STERLING RANCH EAST FILING NO. 2

STERLING RANCH EAST
FILING NO. 2
JOB NO. 1183.31
NOVEMBER 9, 2022
SHEET 1 OF 3

V3_Final Plat Drawings redlines.pdf Markup Summary

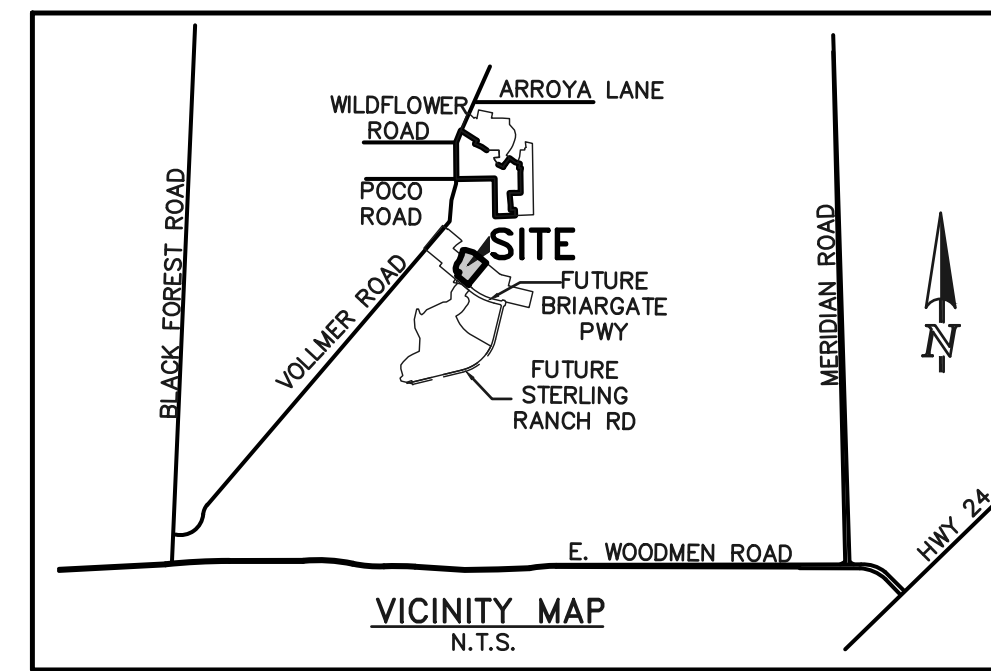
fill in with reception no. from
Homestead North Filing No. 1:
223041857

SHALL BE INSTALLED BY CLASSIC SRC LAND LLC

Unresolved: Delete El Paso County, will be owned and maintained by Metro District except as specified in maintenance agreement

And EPC
